REVISED HONDA VALIDATION TEST REPORT

Revised Report – 1st Copy
November 06, 2000
Document Number ERL-0164
Thomas Sheridan

Product: P-SDI Inflator

To: Bill Martin / Kevin Fitzgerald
From: Tom Sheridan
Subject: Corrected Honda Test data

HONDA PSDI Group 8 (Vibration / Thermal Cycle / Moisture)
@ -35 deg.C (Cold) Simultaneously

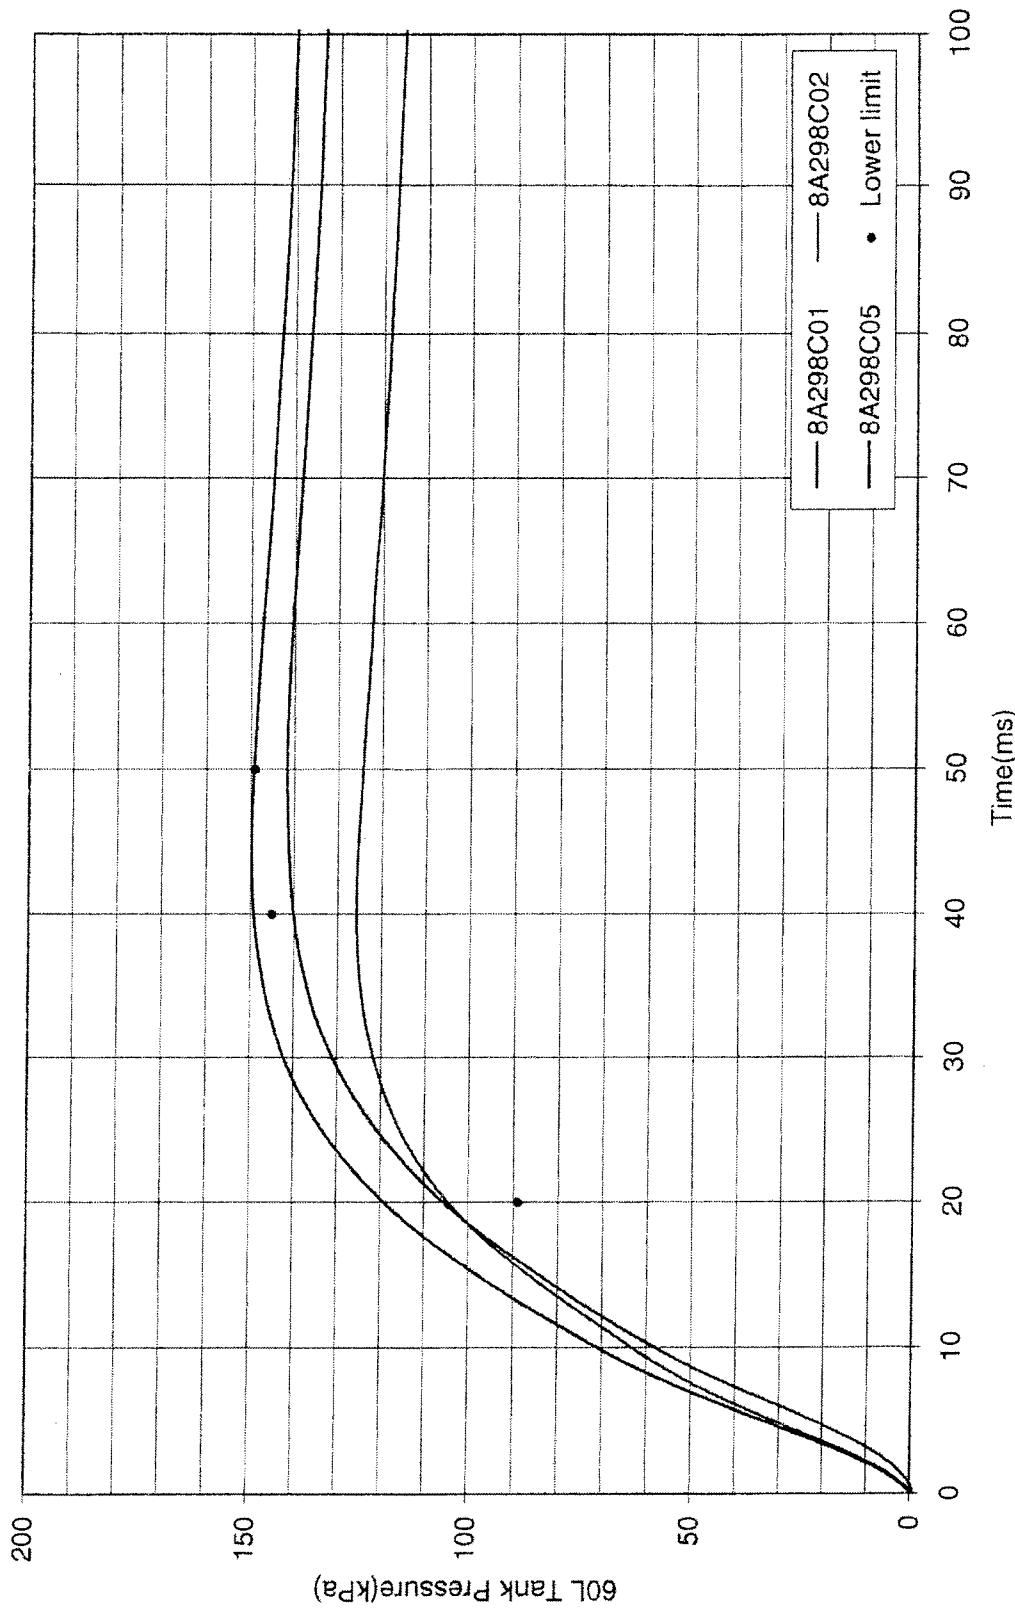
Incorrect data.
Data does not match EAR.
8A298C01, 8A298C02, and
8A298C05 corrected data on
following page.

Corrected chart and data for
8A298 Group C.

HONDA PSDI Group 8 (Vibration / Thermal Cycle / Moisture)
@ +85 deg C (Hot) Simultaneously

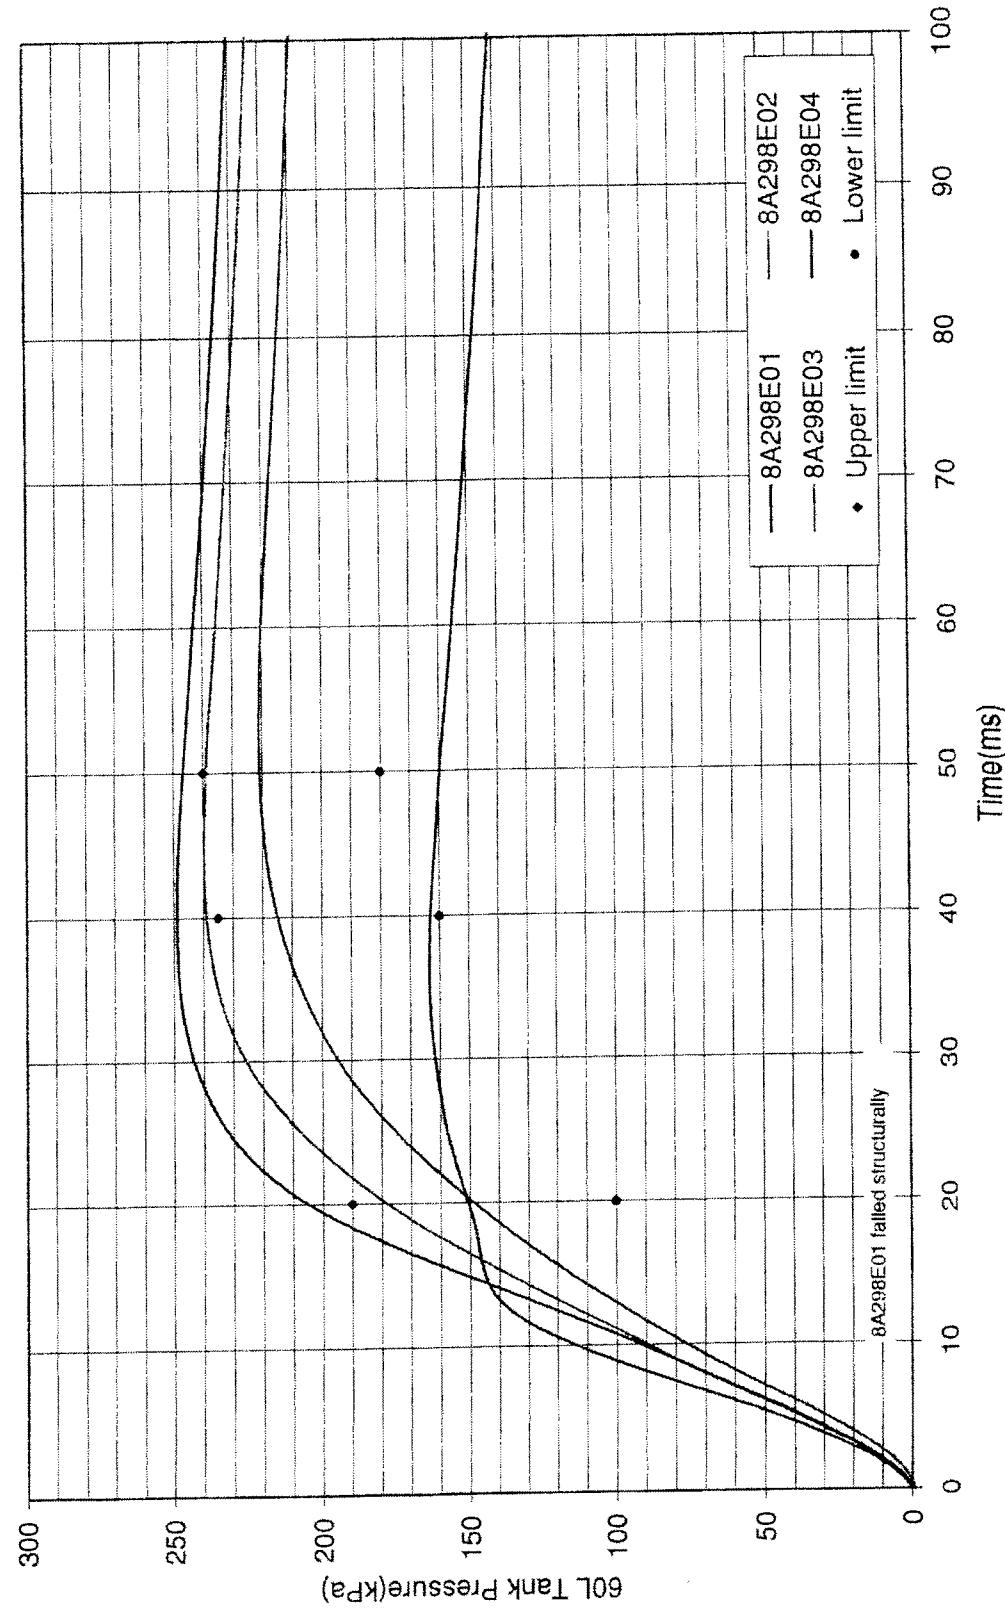
Page 9, labeled Honda PSDI Group 8 (Vibration/Thermal Cycle/moisture) @ 85°C (Hot) Simultaneous, shows (3) deployments. Page 10 shows the correct data. There are (4) deployments. The data does not match. Also, E01 had a pressure vessel failure that was reported as a normal deployment.

Incorrect data.
Data does not match EAR.
8A298E01-8A298E04 corrected
data on following page.

Corrected chart and data for
8A298 Group E.

HONDA PSDI Group 8 (Vibration / Thermal Cycle / Moisture)
@ +85 deg.C (Hot) 20ms delay

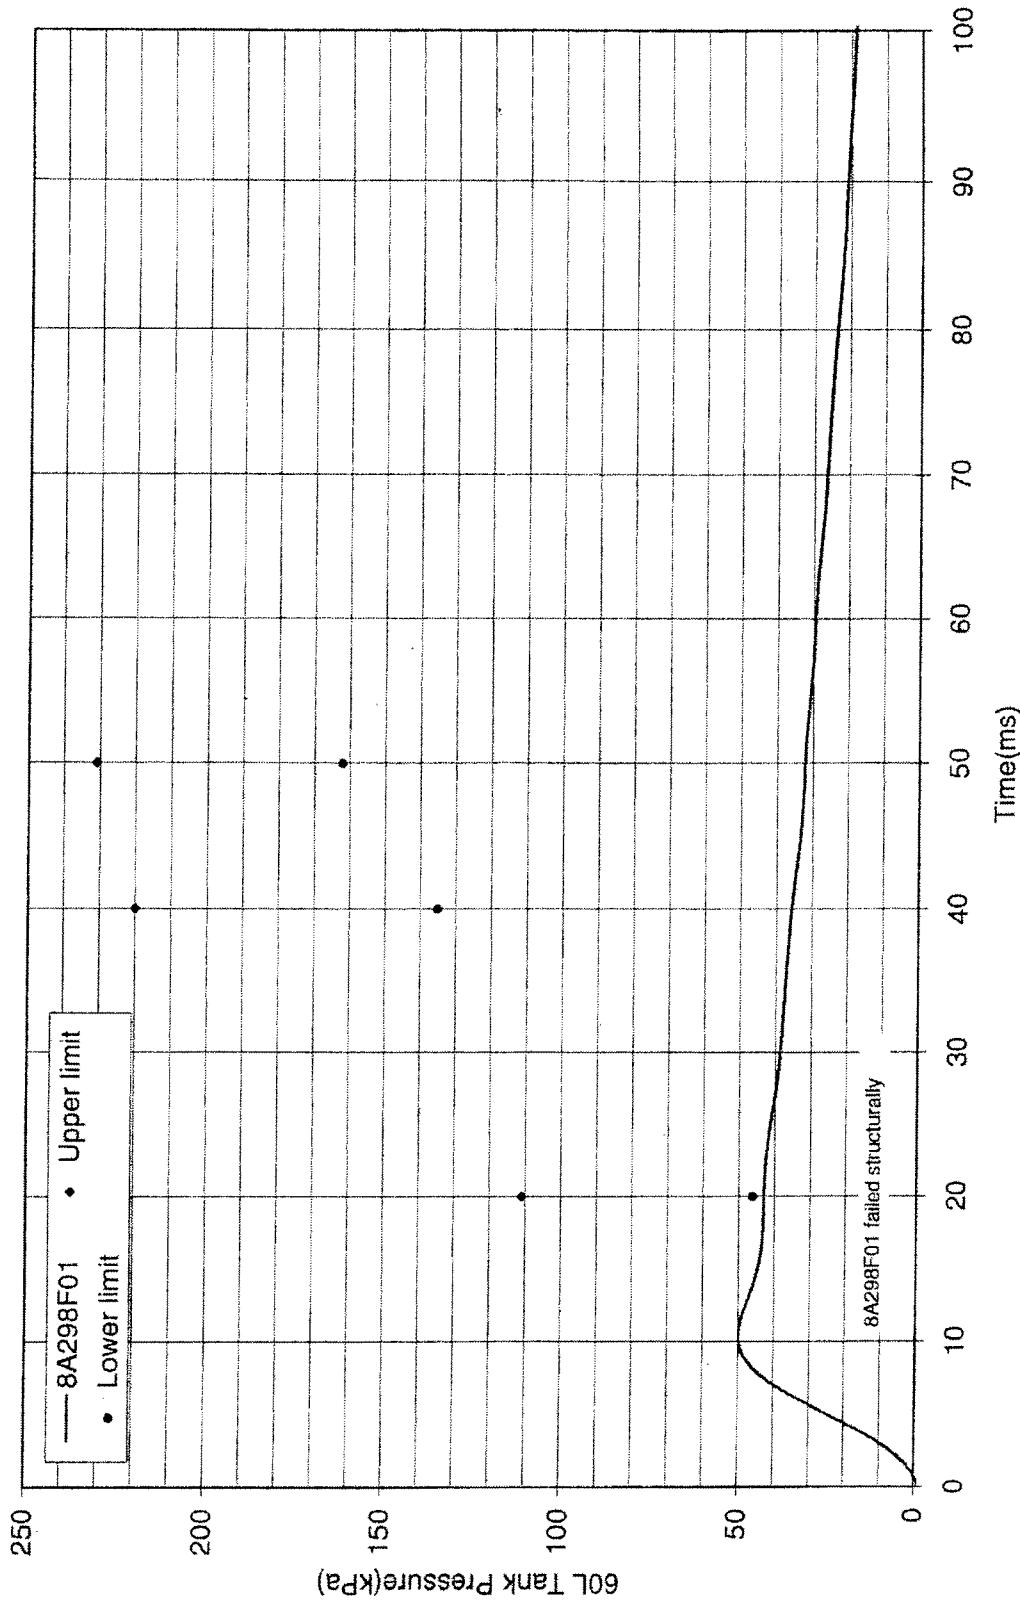
Page 11, labeled Honda PSDI Group 8 (Vibration/Thermal Cycle/moisture) @ 85°C (Hot) 20 ms delay and shows (1) deployment. Page 12 shows the correct data. The data does not match. In Addition, F01 had a pressure vessel failure that was reported as a normal deployment.

Incorrect data.
Data does not match EAR.
8A298F01 corrected data on
following page.

Corrected chart and data for
8A298 Group F.

HONDA PSDI Group 9 (Vibration / Thermal Shock)
@ +22 deg.C (Amb) 20ms delay

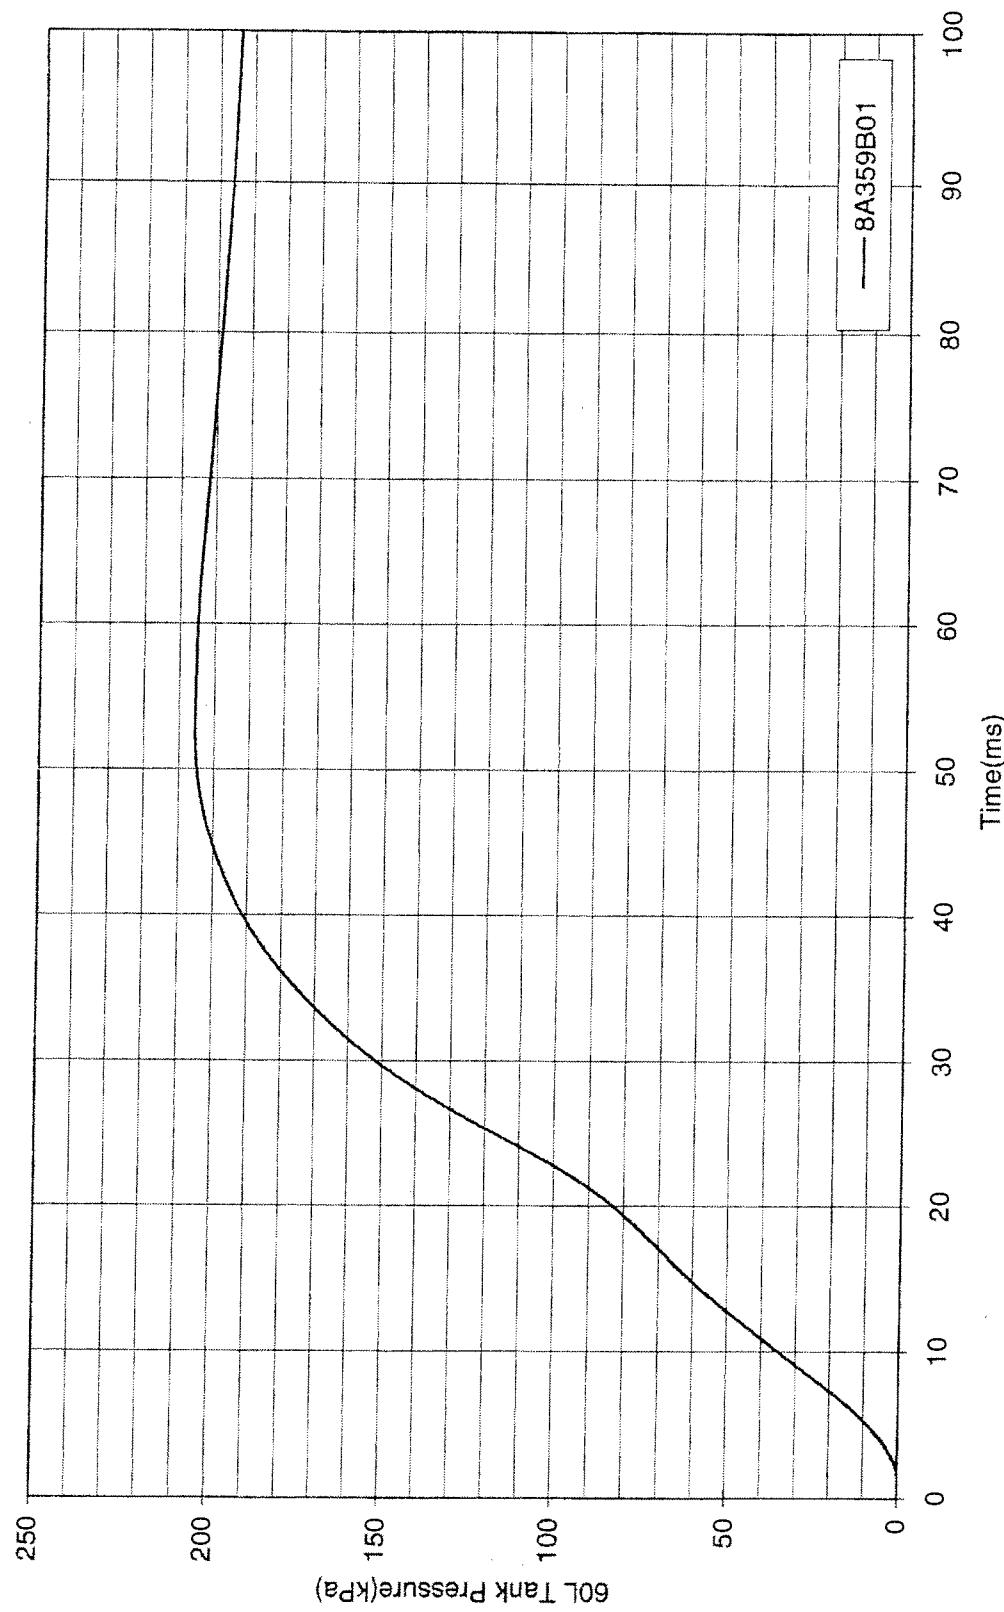
Incorrect data.
Data does not match EAR.
8A359B01 corrected data on
following page.

Corrected chart and data for
8A359 Group B.

HONDA PSDI Group 9 (Vibration / Thermal Shock)
@ -35 deg.C (Cold) Simultaneously

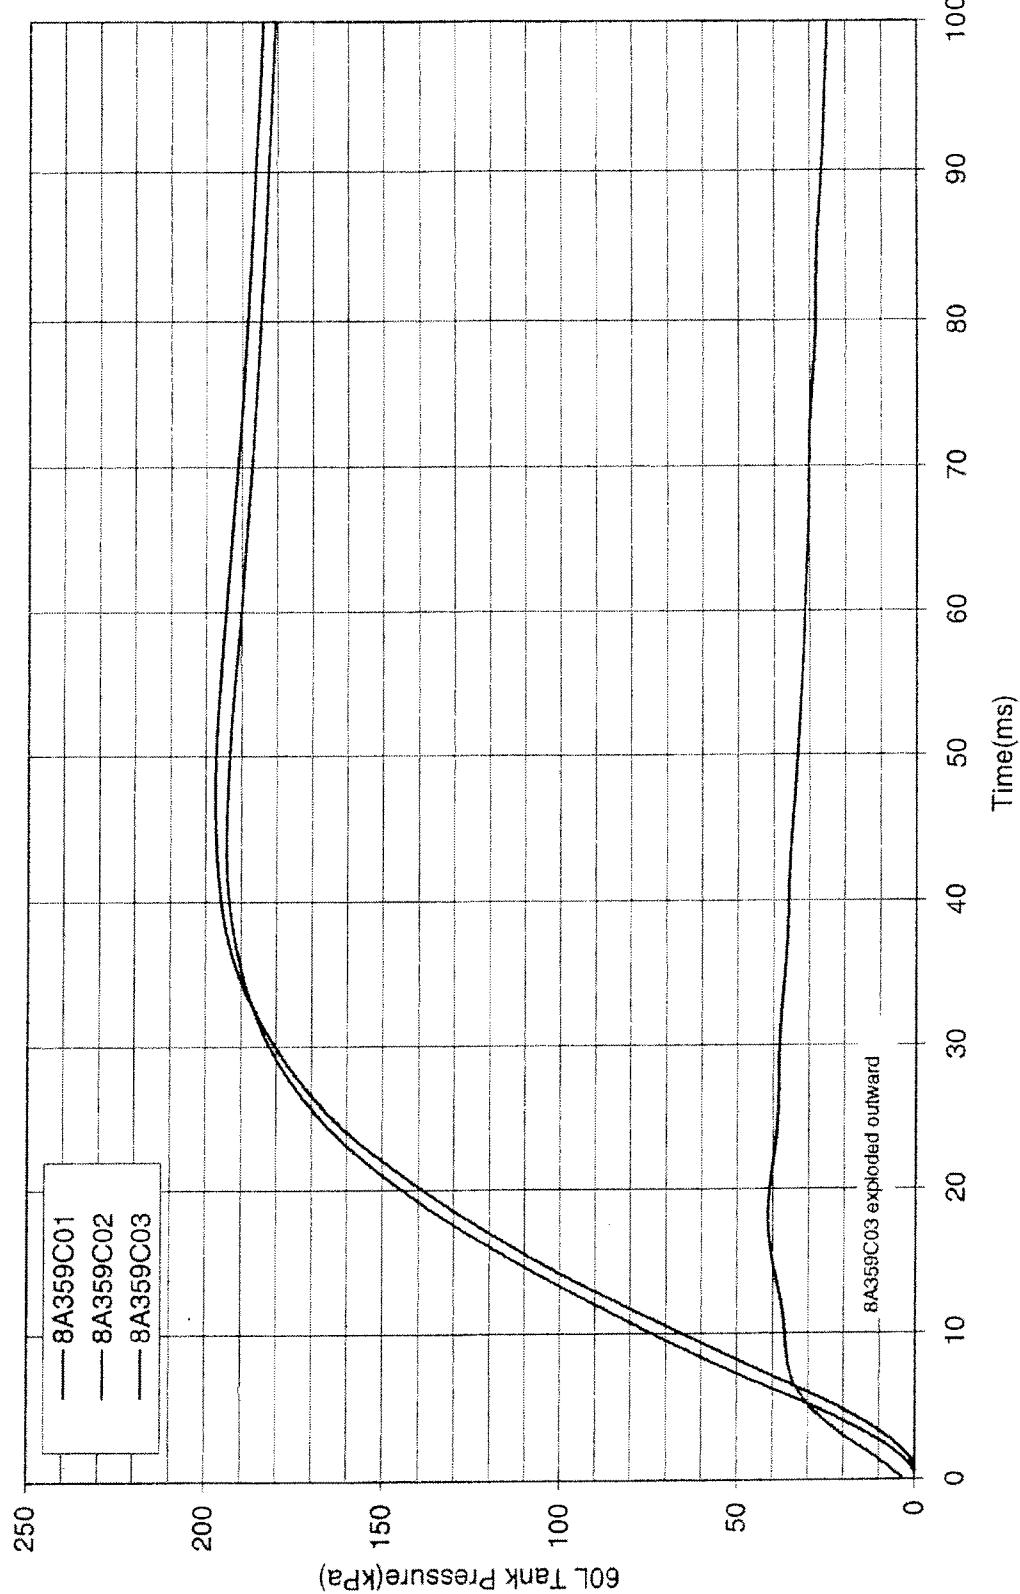
Page 5, labeled Honda PSDI Group 9 (Vibration/Thermal Shock) @ -35°C (Cold) Simultaneous, shows (3) deployments. Page 6 shows the correct data. The data does not match. In Addition, CO3 had a pressure vessel failure, but was reported as a normal deployment.

Incorrect data.
Data does not match EAR.
8A359C01-8A359C03 corrected
data on following page.

Corrected chart and data for
8A359 Group C.

HONDA PSDI Group 9 (Vibration / Thermal Shock)
@ -35 deg.C (Cold) 20ms delay

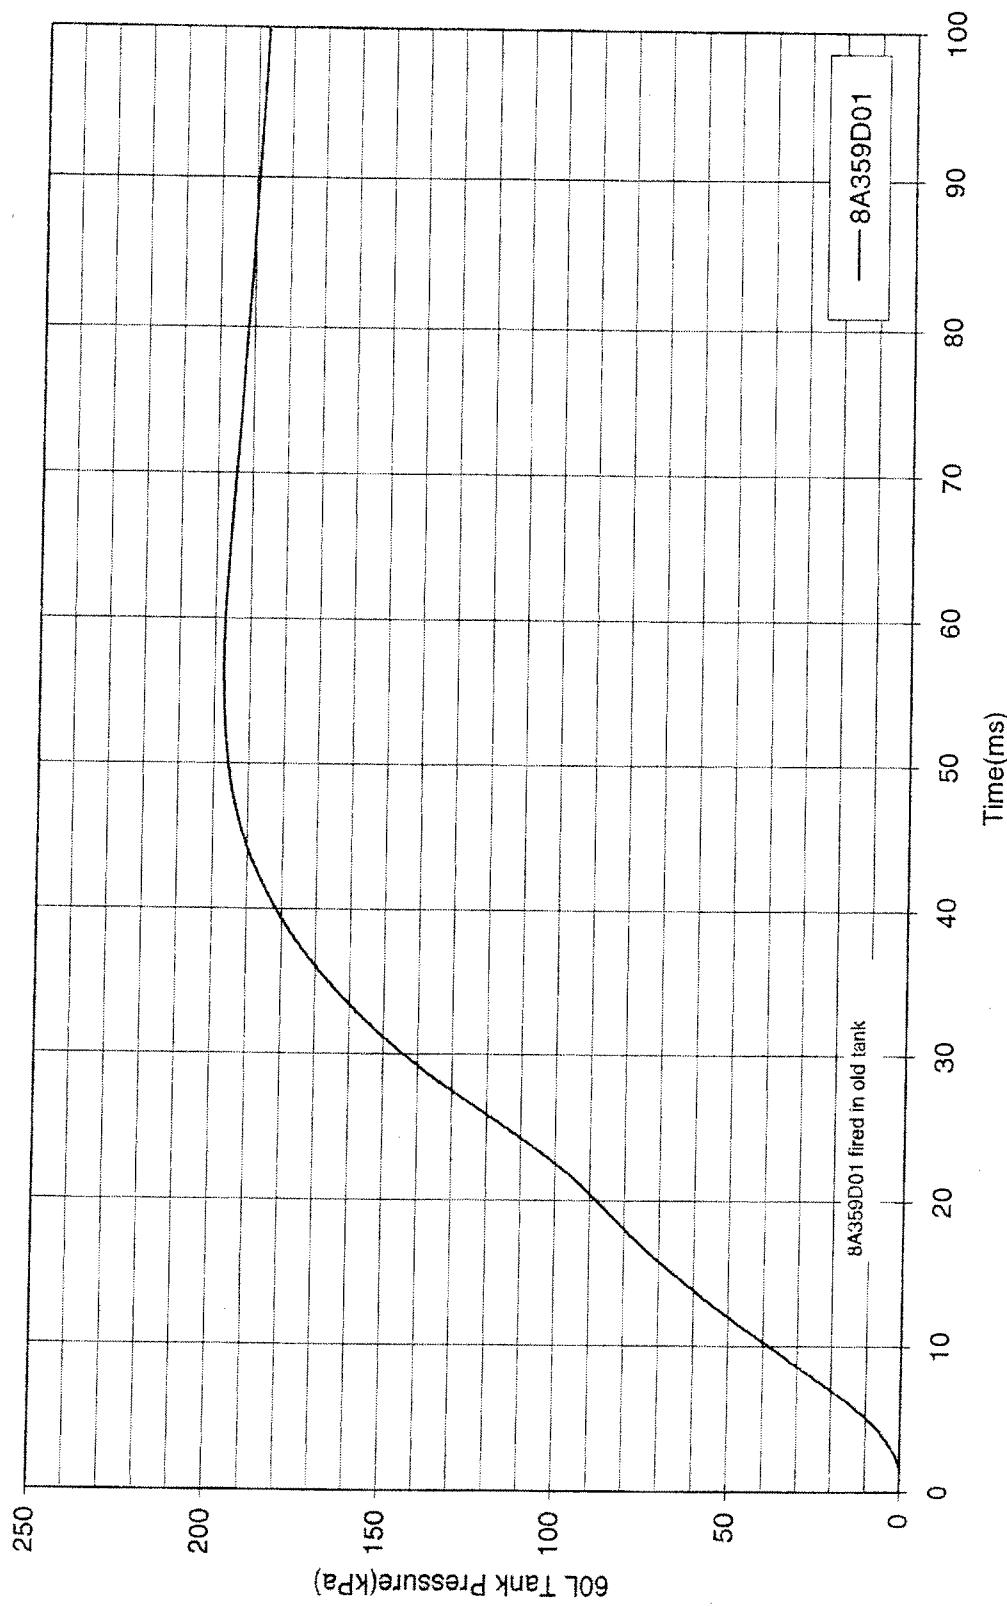
Incorrect data.
Data does not match EAR.
8A359D01 corrected data on
following page.

Corrected chart and data for
8A359 Group D.
